#### PLAT COMMITTEE

**Case Number:** 2024-PLT-020 **Property Address:** 1401 Woodlawn Ave. (Approximate Address) Location: Center Township, Council District # 18 Sunrise Results, LLC, by John Cross Petitioner: Zoning: D-5 **Request:** Approval of a Subdivision Plat to be known as Laurel Woodlawn Townhomes, subdividing 0.11 acres into two single-family attached lots. Waiver Requested: None Current Land Use: Residential Staff Reviewer: Jeffrey York, Principal Planner I

**Preliminary Plat**

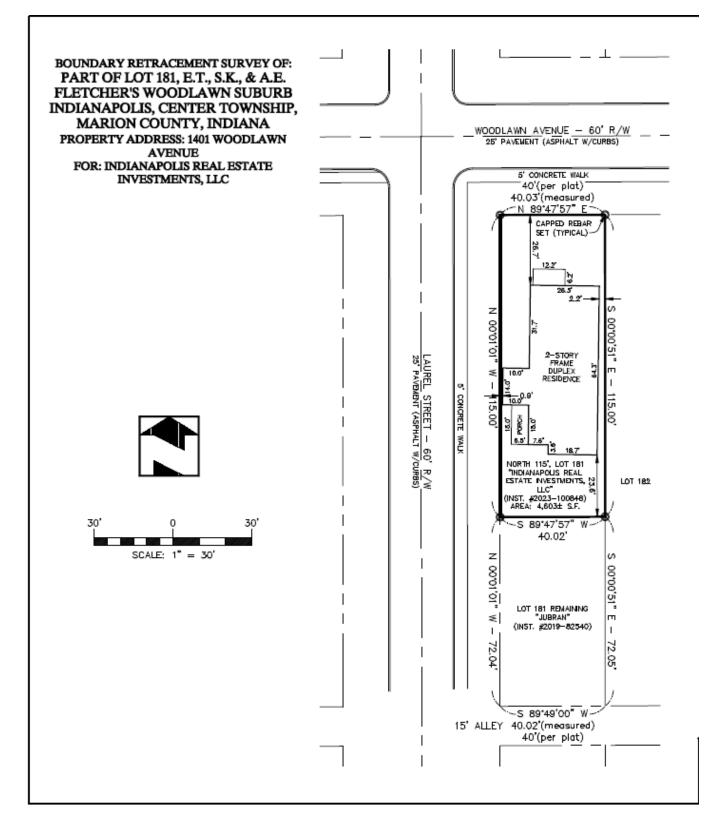
The subject site is zoned D-5 Residential. There is currently a two-family multi-unit on site. The Petitioner intends to subdivide the property between the two units. The structure was built prior to 1900. All setbacks associated are deemed as Legal Nonconforming. This proposed plat meets the Zoning and Subdivision Control Ordinance.

Staff recommends that the Plat Committee **approve** and find that the plat, file-dated March 27, 2024, complies with the standards of the Subdivision regulations, subject to the following conditions:
